CITY PLAN COMMISSION

FILE NUMBER: S234-212

REQUEST: An application to create one 9.636-acre lot from a tract of land in City Block 6866 on property located on Simpson Stuart Road at Highland Hills Drive, southeast corner.

PRELIMINARY PLAN
FREDERICK D. HAYNES
PREPARATORY ACADEMY
 LOT 1, BLOCK A/6886
 BEING A PART OF THE JOHN B. RICHARDS SURVEY, INSTRUMENT NO. 1192
 CITY OF DALLAS, TEXAS
 CITY PLAN FILE NO. S234-212
 SEPTEMBER 23, 2024

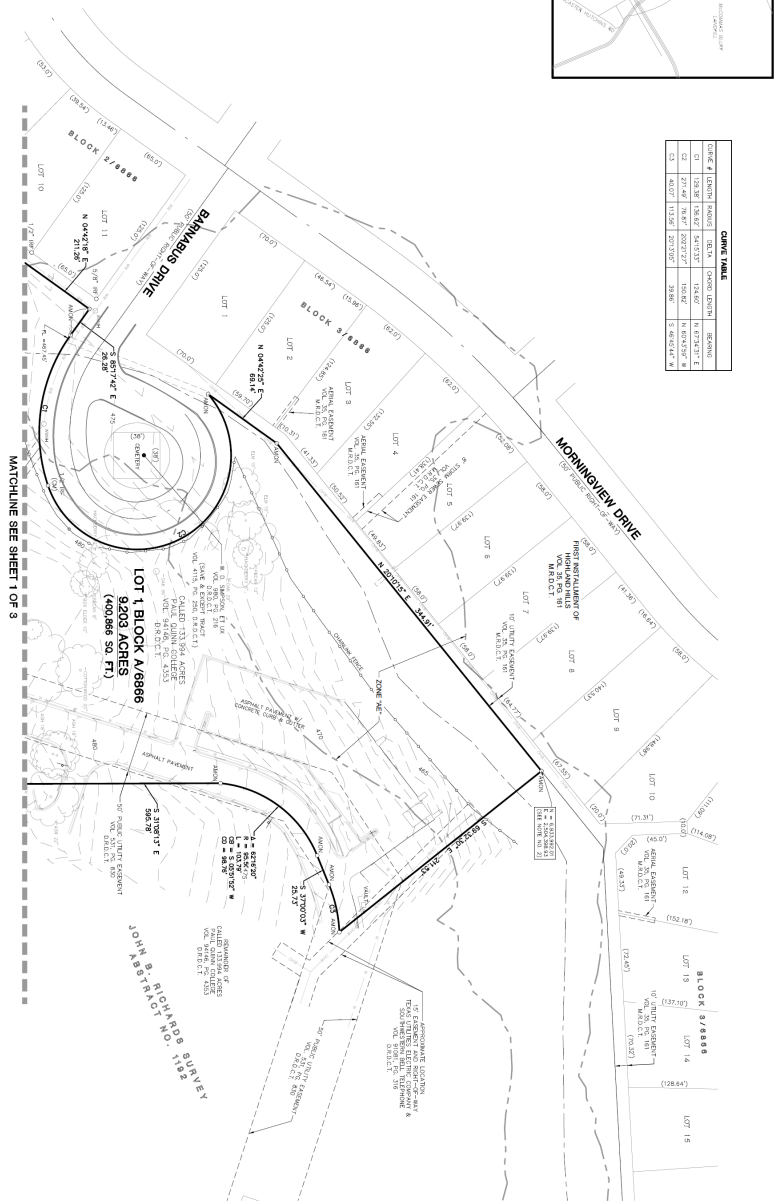
16. On the final plat, dedicate 53.5 feet of right-of-way (via fee simple) from the established center line of Simpson Stuart Road. *Section 51A 8.602(c)*
17. On the final plat, dedicate 28 feet of right-of-way (via fee simple or street easement) from the established centerline of Highland Hills Drive. *Sections 51A-8.602(c), 51A-8.604(c) and 51A-8.611(c).*
18. On the final plat, dedicate a minimum 10-foot by 10-foot corner clip (via fee simple or street easement) at the intersection of Highland Hills Drive & Simpson Stuart Road. Section 51A 8.602(d)(1)
19. Must coordinate with Transportation Department for any traffic signal requirements that are deemed necessary for improving pedestrian accessibility and safety related to site development (Contact Srinivasa Veeramallu with Traffic Signals). *51A-8.606, 51A-8.608*

20. On the final plat, determine the 100-year water surface elevation across this addition.

21. On the final plat, dedicate floodway easement, floodway management area or floodway easement (within common area), with the appropriate easement statement included on the face of the Plat. 51A 8.611(d); DWU Floodplain Management; Drainage Design Manual Addendum V

23. On the final plat, specify minimum fill and minimum finished floor elevations. *Section 51A-8.611(d), Trinity Watershed Management.*
24. On the final plat, show the natural channel set back from the crest of the natural channel. *Section 51A-8.611(d), Trinity Watershed Management.*

31. Existing and any proposed Water and Wastewater Easements must be shown and/or increased to conform to current design standards. **Notice:** Minimum DWU easement size 20' for one utility and 25' for both water and sewer. Larger diameter or deeper mains may require additional width.

33. Prior to the final plat, please provide a copy of documentation from the City of Dallas and Utility Companies which allows the gate and supporting structure for the gate to be located across the 50' Public Utility Easement dedicated by Vol. 531, Pg. 830.
34. On the final plat, provide documentation for "County Road No. 304".
35. On the final plat, identify the property as Lot 1 in City Block B/6866.
